ADDENDUM

Date Issued:	February 18, 2022
Project:	Intermountain Healthcare Linear Accelerator Replacement at LDS Hospital 8 th Avenue, C Street Salt Lake City, Utah 84143
Addendum Number:	1

**Intermountain Healthcare
Linear Accelerator Replacement at
LDS Hospital**

Demolition
Floor Plan
Level 1

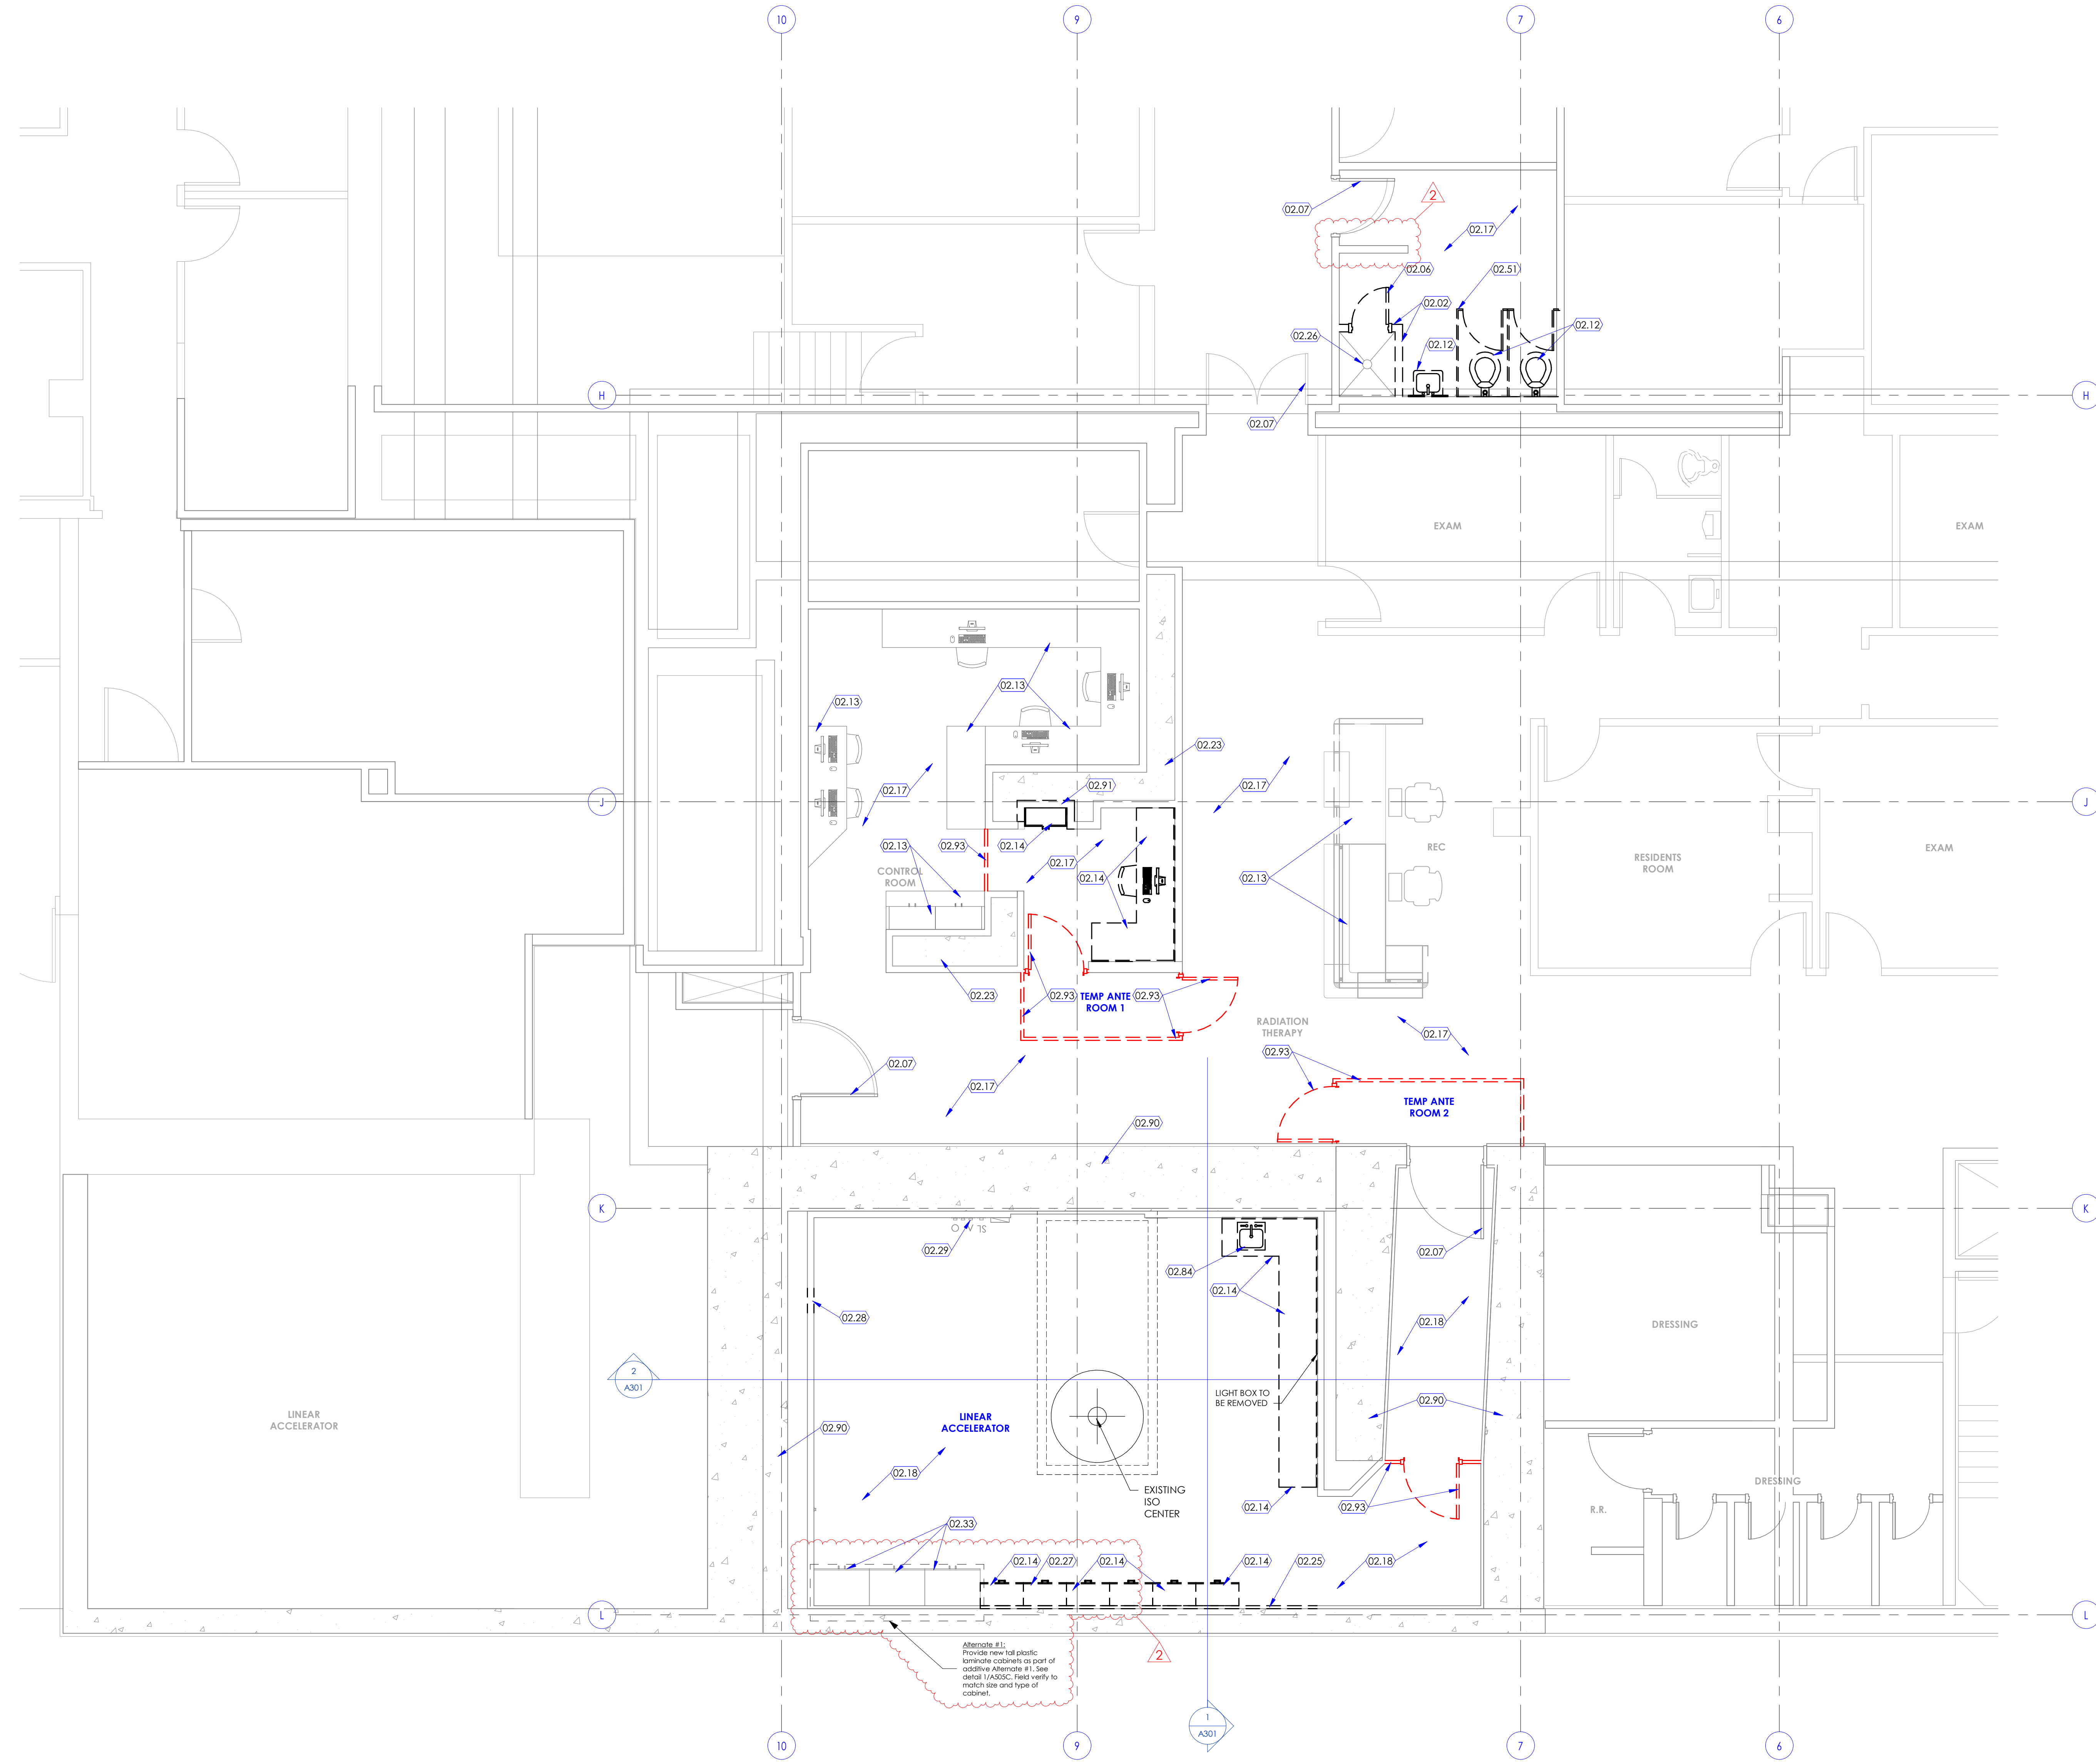
Sheet Number	Drawings
Architectural Drawings	
A111	See attached sheet with revision shown clouded.
A112	See attached sheet with revision shown clouded.
A113	See attached sheet with revision shown clouded.

Alternate #1:
Provide new top plastic laminate cabinets as part of existing Alternate #1. See detail A303C. Fabric verify to match size and type of cabinet.

Enlarged
 Floor Plan
 Level 1

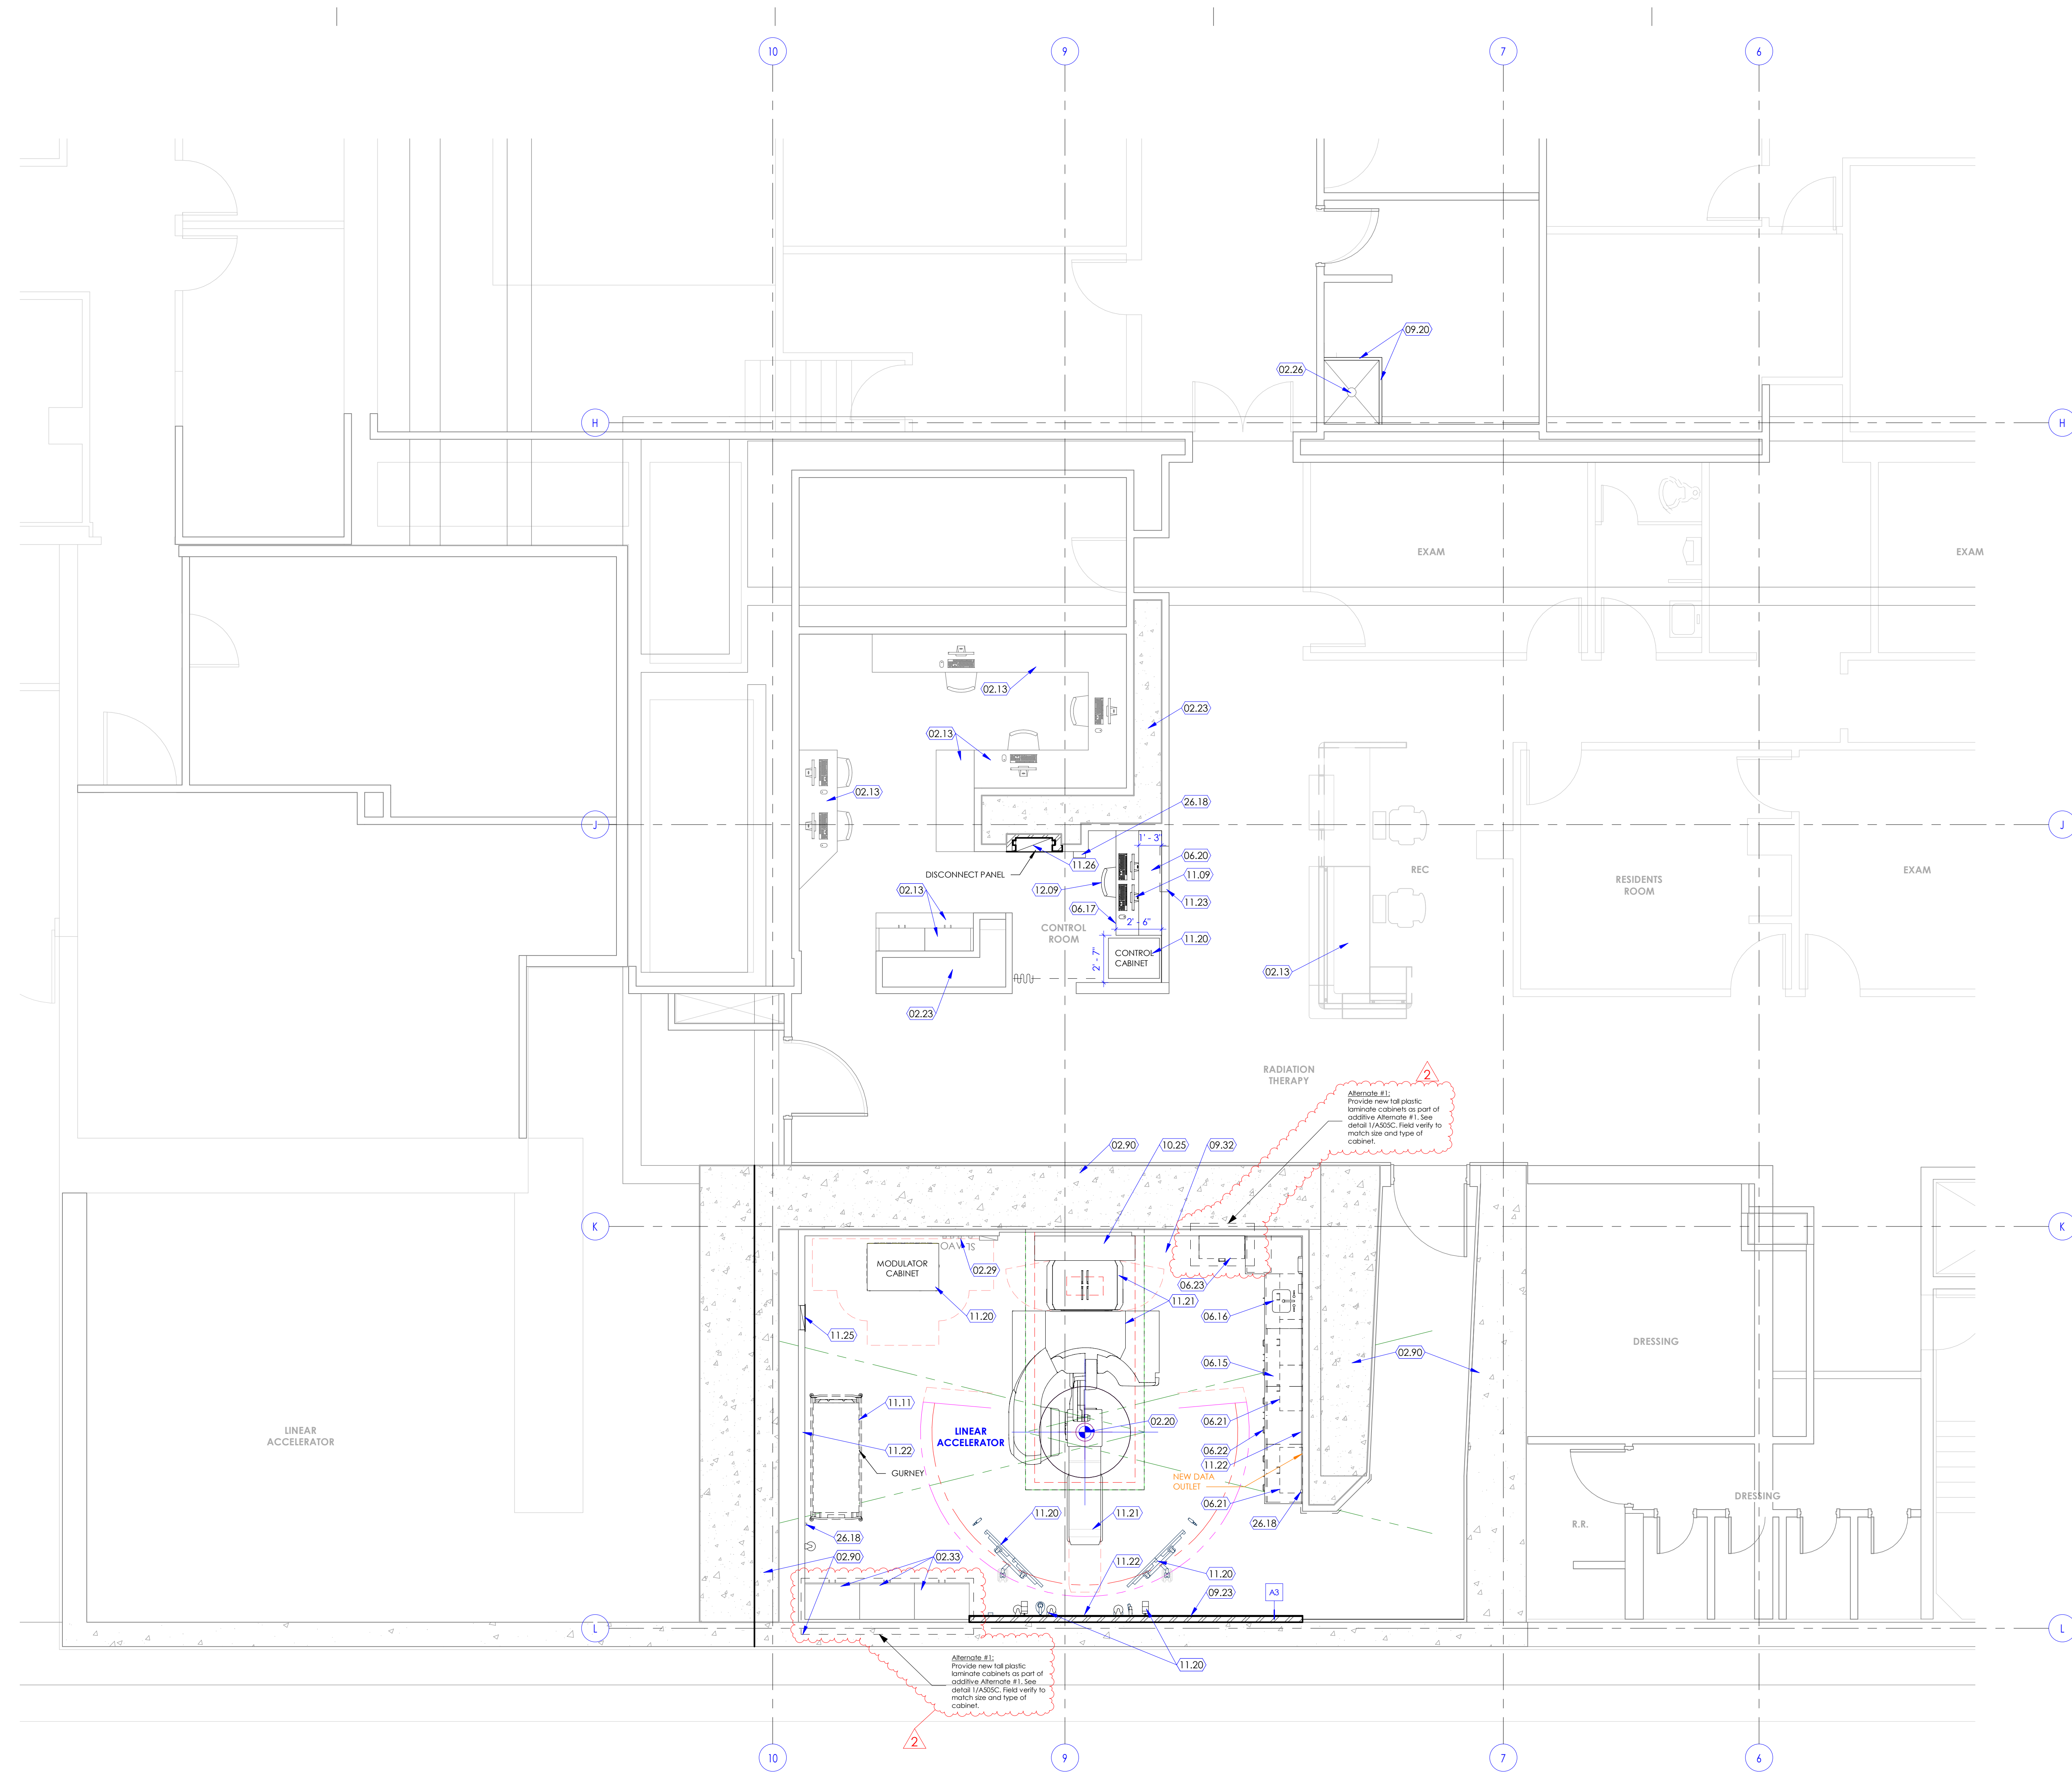
- 09.32 RUN NEW SHEET VINYL FLOORING OVER A REMOVABLE METAL PLATE TO COVER THE EXISTING FLOOR OPENING HERE TO ACCESS PLUMBING CONNECTIONS. FIELD VERIFY EXISTING CONDITIONS.

- 10.25 STAINLESS STEEL METAL PLATE. CUT TO SIZE TO COVER THE LEFT OVER FLOOR HOLE BEHIND THE NEW VARIAN EQUIPMENT IN THIS AREA. FIELD VERIFY EXACT SIZE BEFORE FABRICATION. COORDINATE WITH THE OWNER.
